ASD Technology	
		PRODUCT:	T2-2M pixel
		PCB NUMBER:	<OrgAddr2>
		DESIGN ENGINEER:	ASD
Title			
1-T2 MAIN			
Size	Document Number	Rev	
B	T2-M-030526-V2-1.DSN	2.1	
Date:		Monday, May 26, 2003	Sheet 1 of 9

ASD Technology	
		PRODUCT:	T2-2M pixel
		PCB NUMBER:	<OrgAddr2>
		DESIGN ENGINEER:	ASD
Title			
3-SOCKET (OV9620)			
Size	Document Number		Rev
A	T2-M-030526-V2-1.DSN		2.1
Date:	Monday, May 26, 2003		Sheet 3 of 9

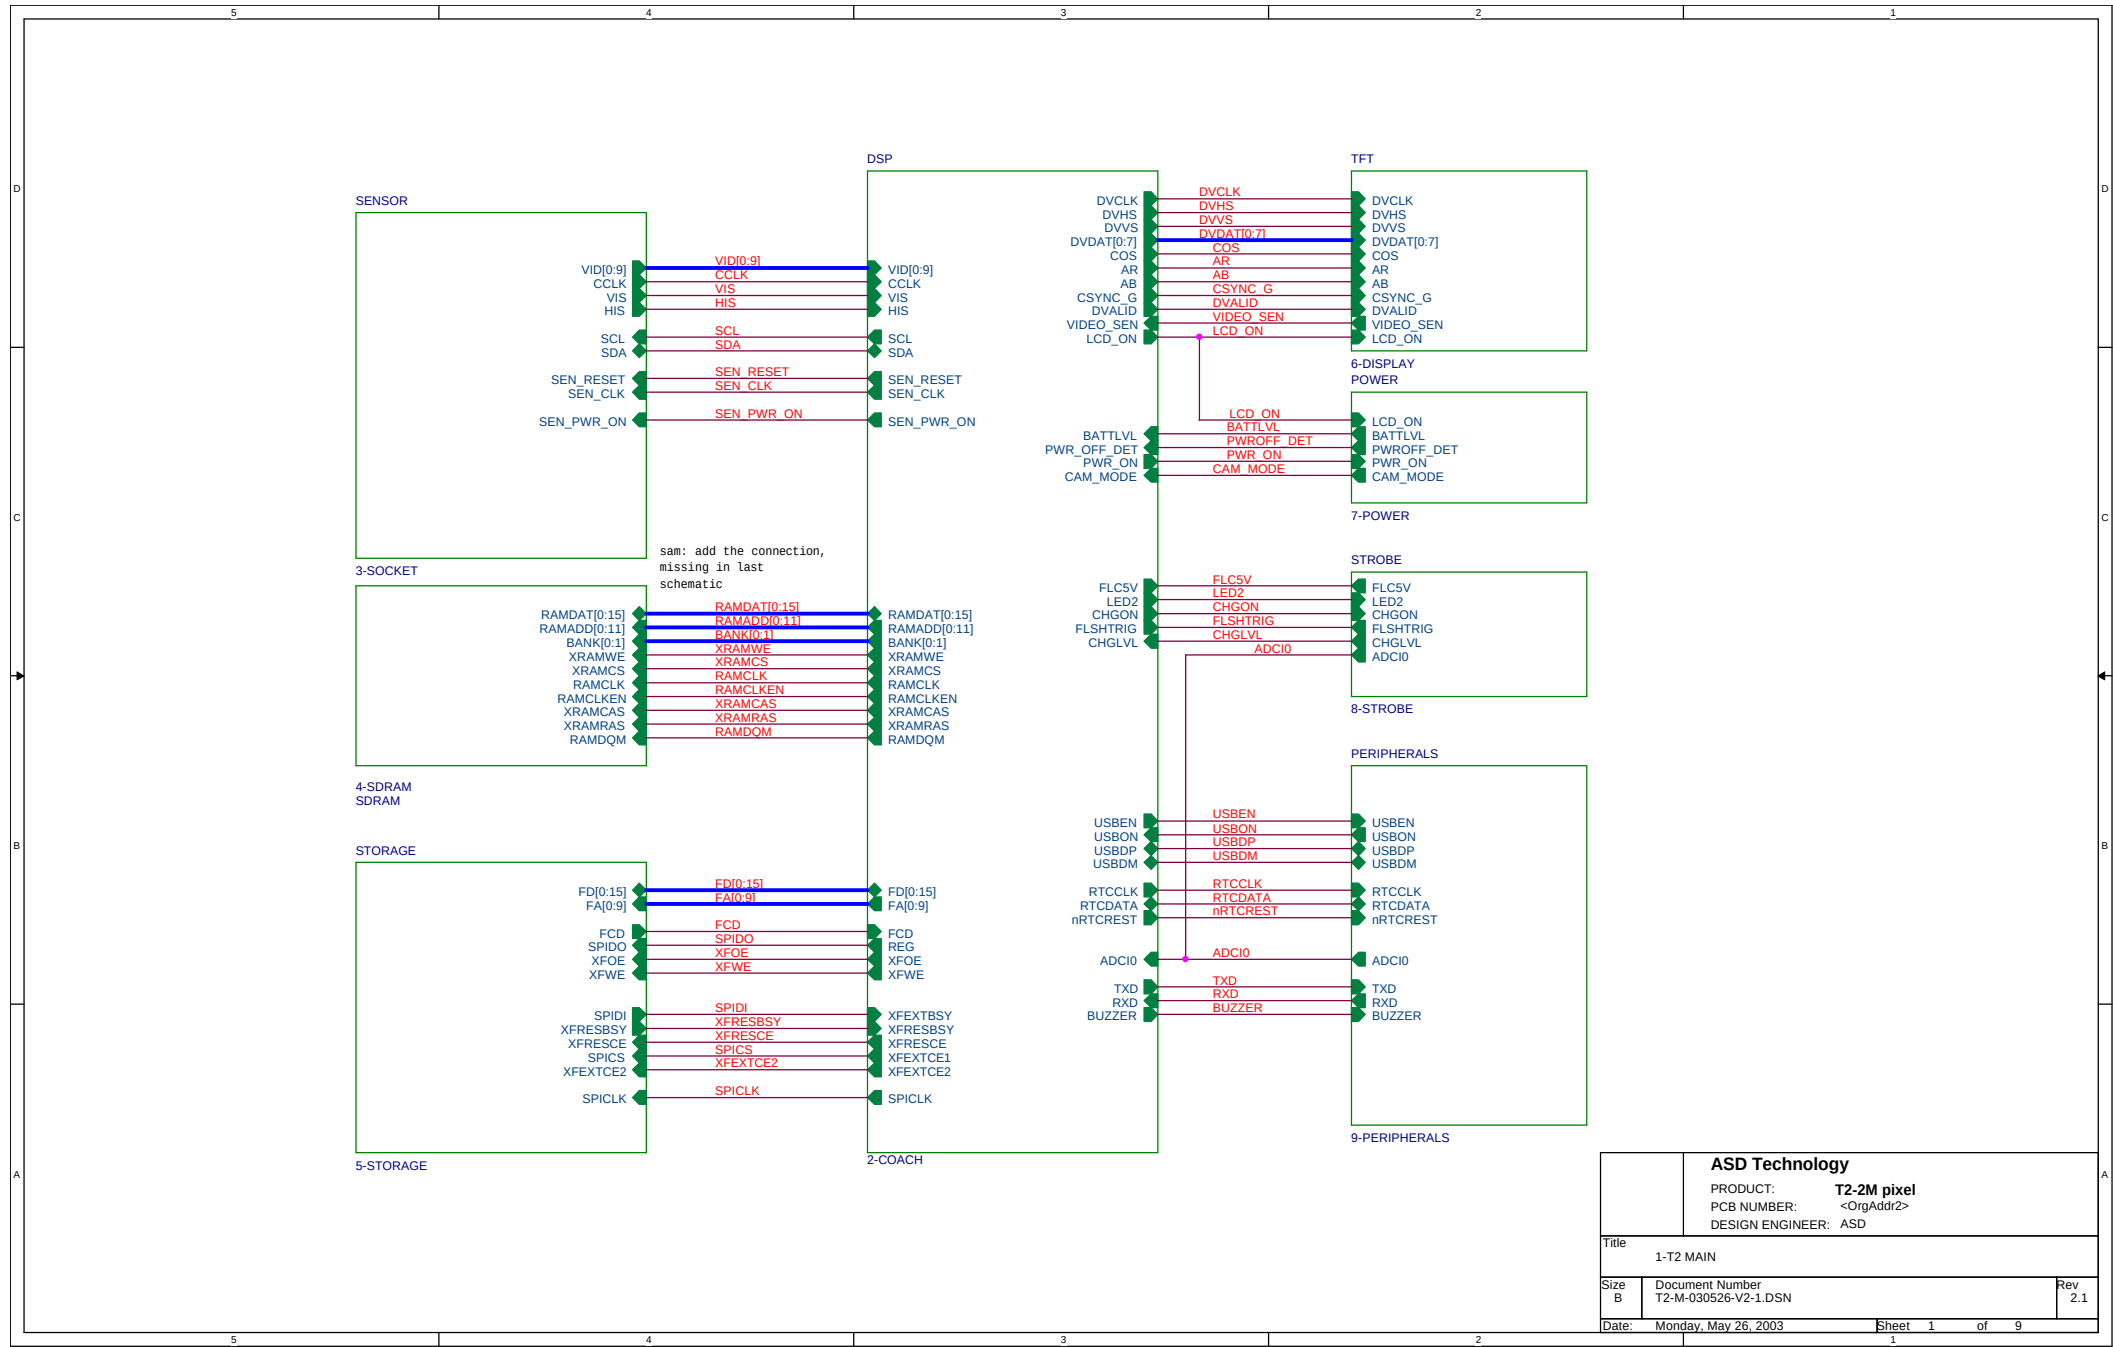
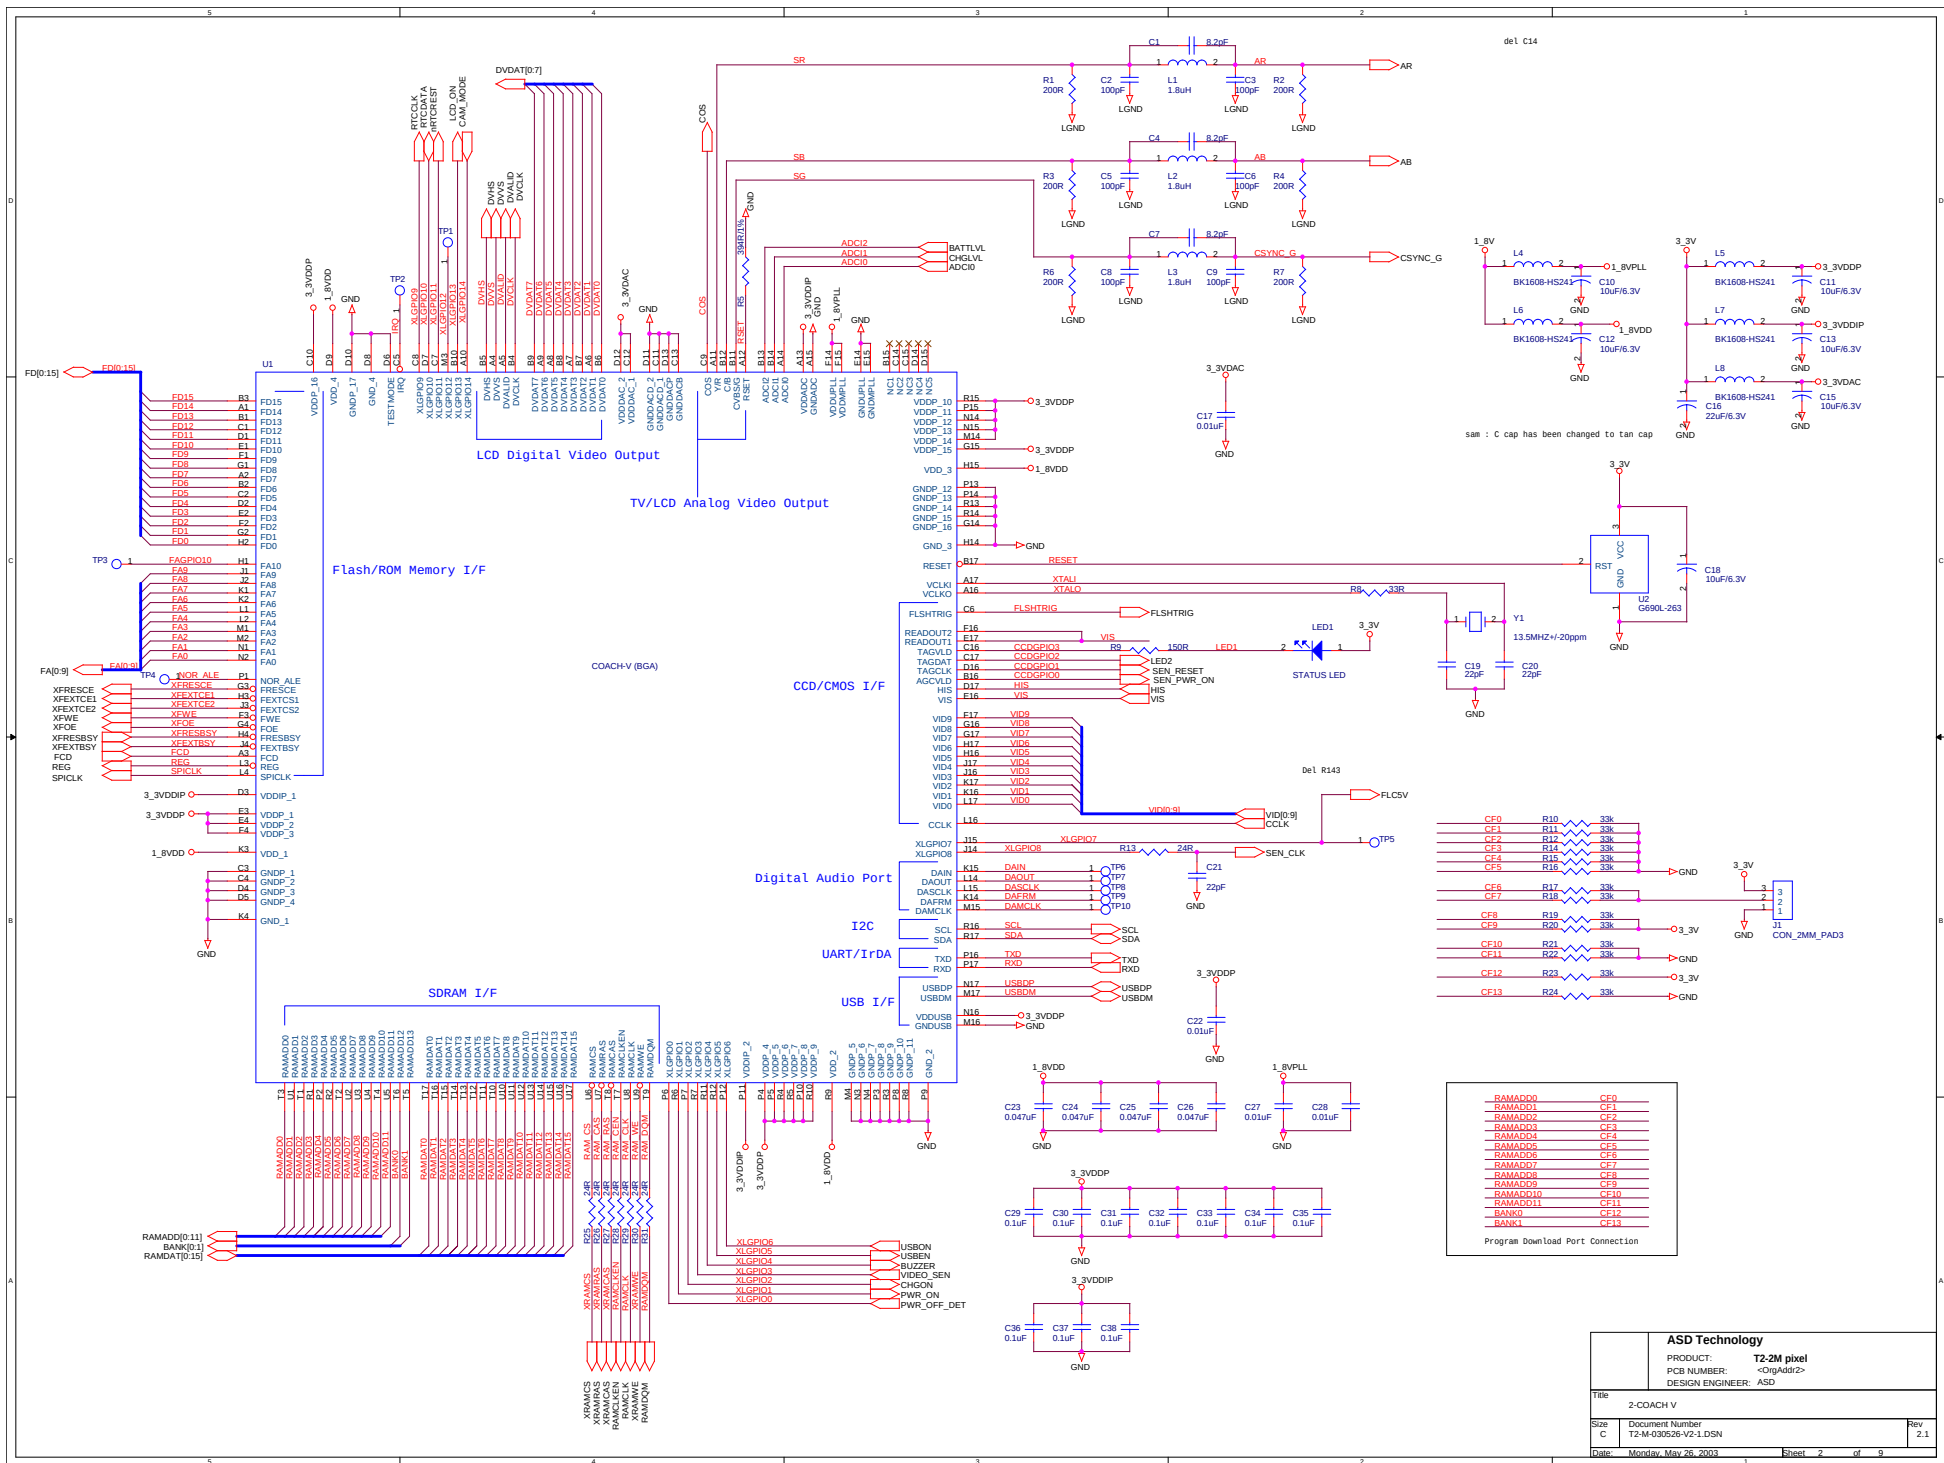
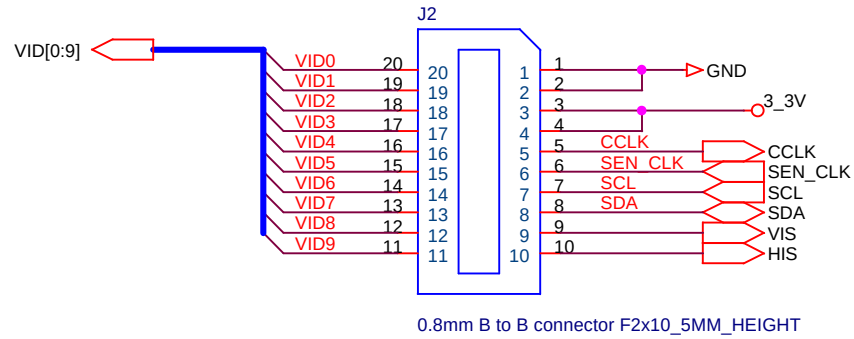
CHANGE GND TO
SAGND AND SDGND

sam: ccdgpio2 typing
error, change to led2
for better
recognition.

The external connected cap of VcCHG1,VcCHG2 is advised
value 1u

ASD Technology	
PRODUCT:	T2-2M pixel
PCB NUMBER:	<OrigAddr2>
DESIGN ENGINEER:	ASD
Title 7-POWER	
Size B	Document Number T2-M-030526-V2-1.DSN
Date: Monday, May 26, 2003	Sheet 7 of 9
Rev 2.1

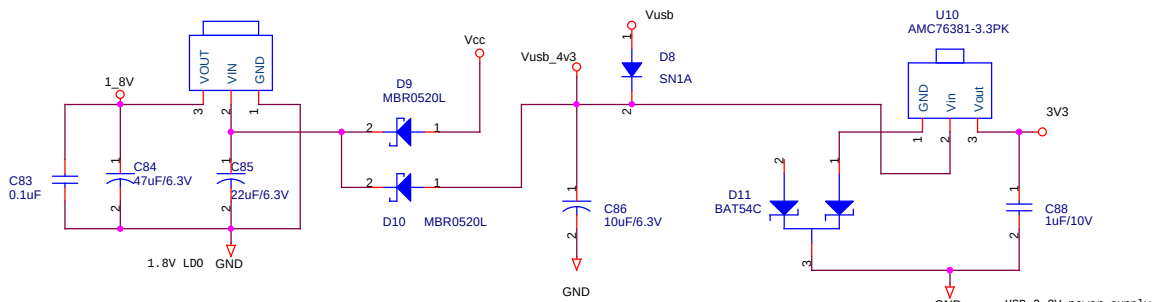
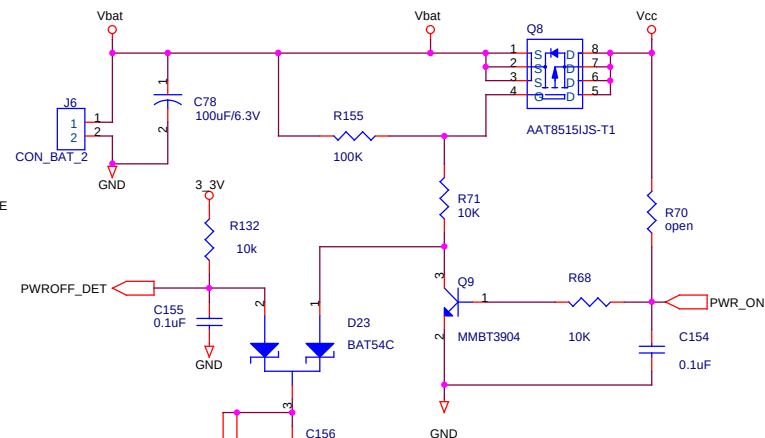
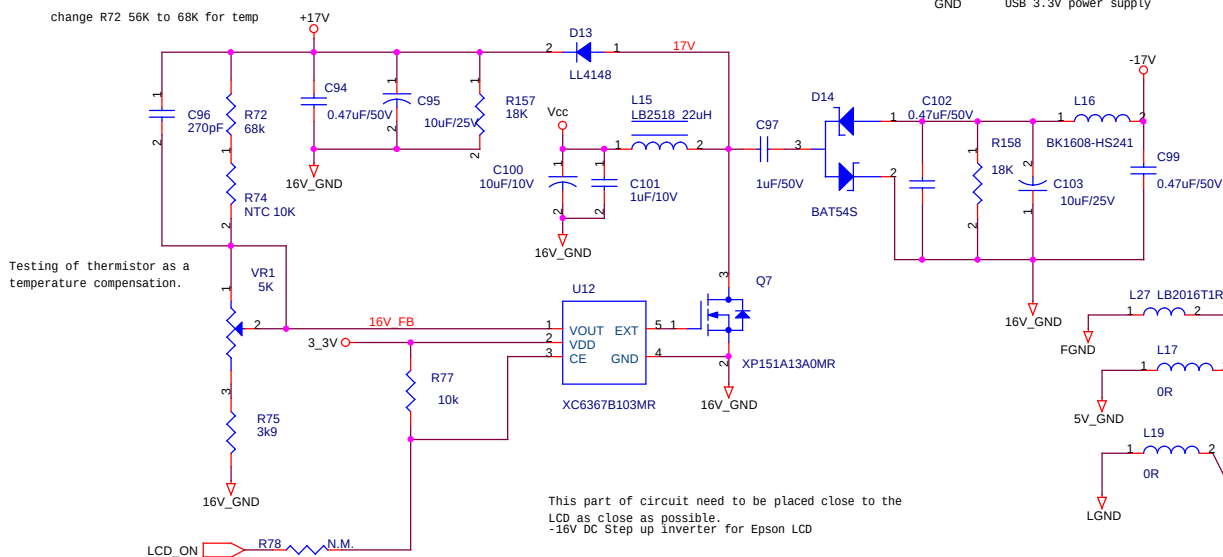
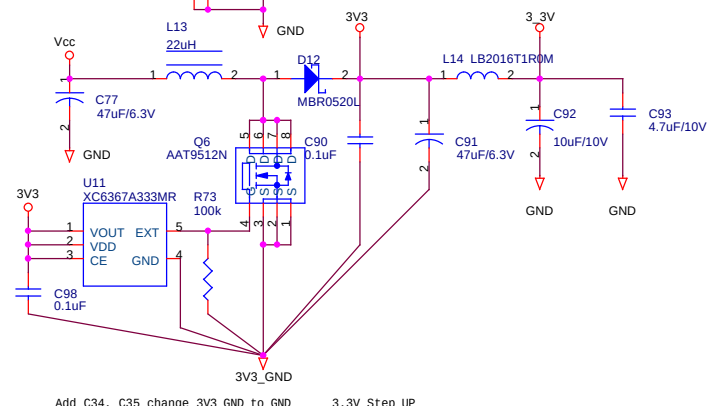
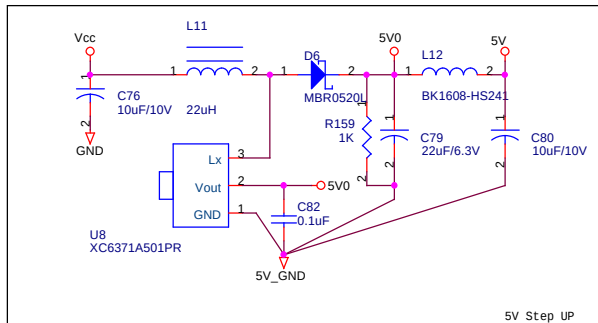
Change R75 and R88 6-5-2003
